CES Class VI Permit Application Review

Overview

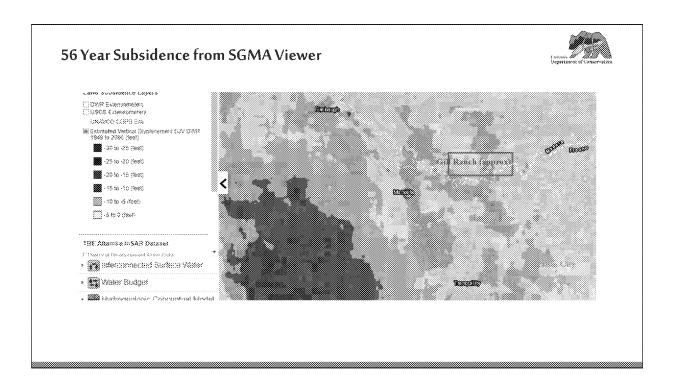
• The minimum recording frequency of 5 min in Table 2 of Attachment C seems long. A 1 minute recording frequency is suggested.
